**SUNDRY NOTICES AND REPORTS ON WELLS**  
*Do not use this form for proposals to drill or to re-enter an abandoned well. Use Form 3160-3 (APD) for such proposals.*

**Jicarilla 29-02-21 #2**  
NE, Section 21, T29N, R2W  
Rio Arriba County, New Mexico

## PLUG AND ABANDONMENT PROCEDURE

Re: Permanent Abandonment  
Well: 2 Jicarilla 29-02-21

### Proposed Plugback

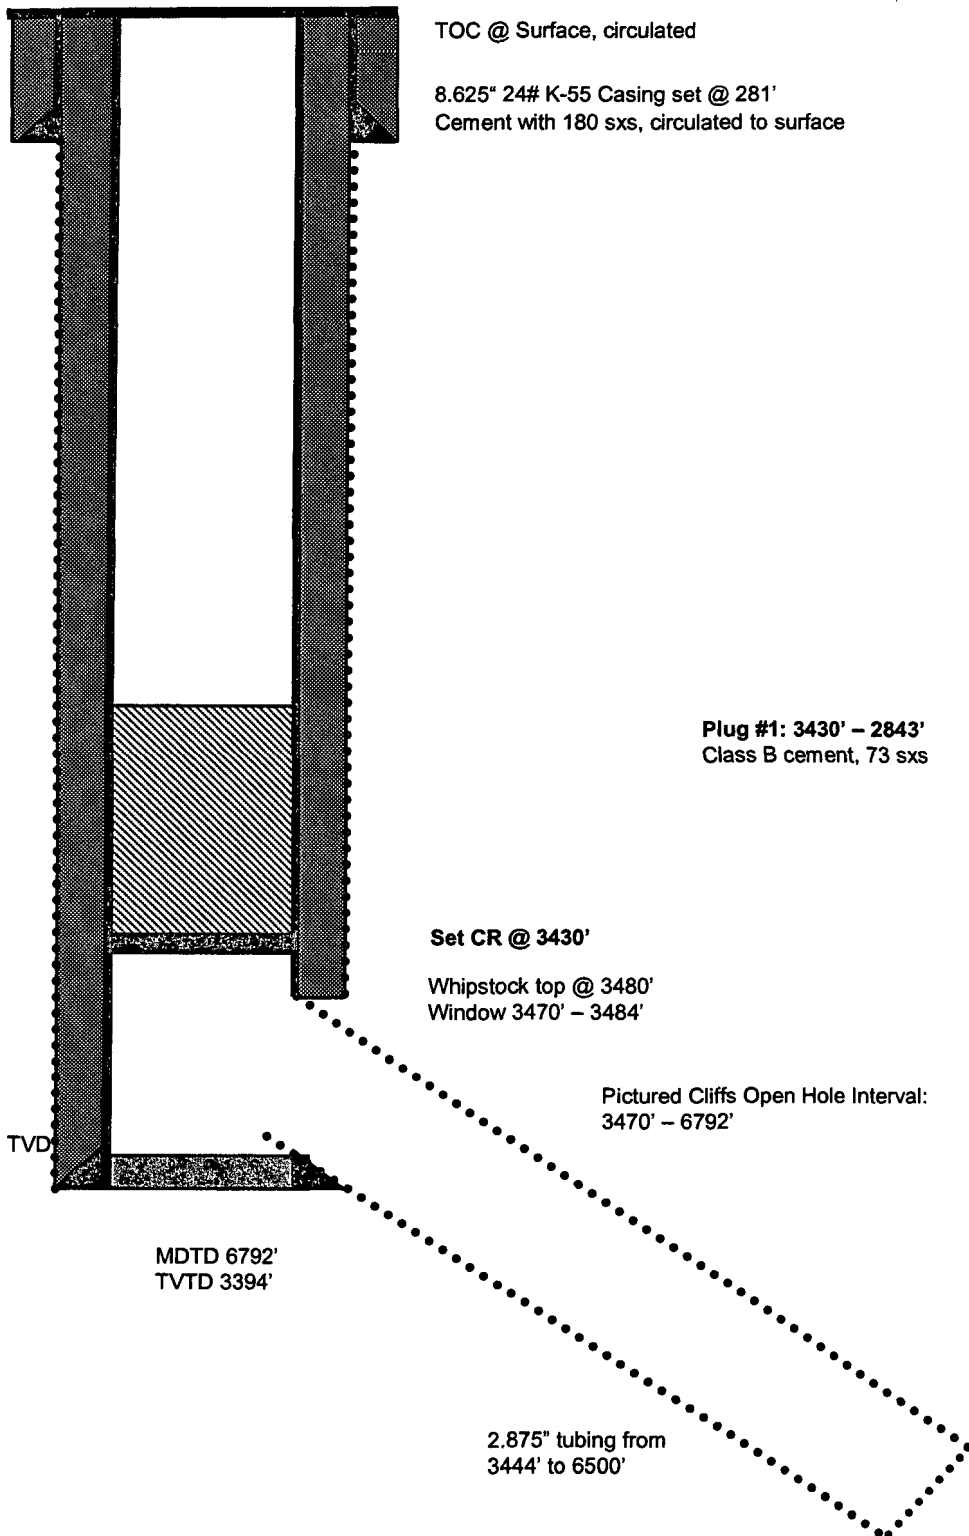
1. Plugging operations authorized are subject to the attached "General Requirements for Permanent Abandonment of Wells on Federal and Indian Lease."
2. Farmington Office is to be notified at least 24 hours before the plugging operations commence (505) 599-8907.
3. The following modifications to your plugging program are to be made:
  - a) Place the Pictured Cliffs/Fruitland/Kirtland/Ojo Alamo plug from 3430' – 3030'.

You are also required to place cement excesses per 4.2 and 4.4 of the attached General Requirements.
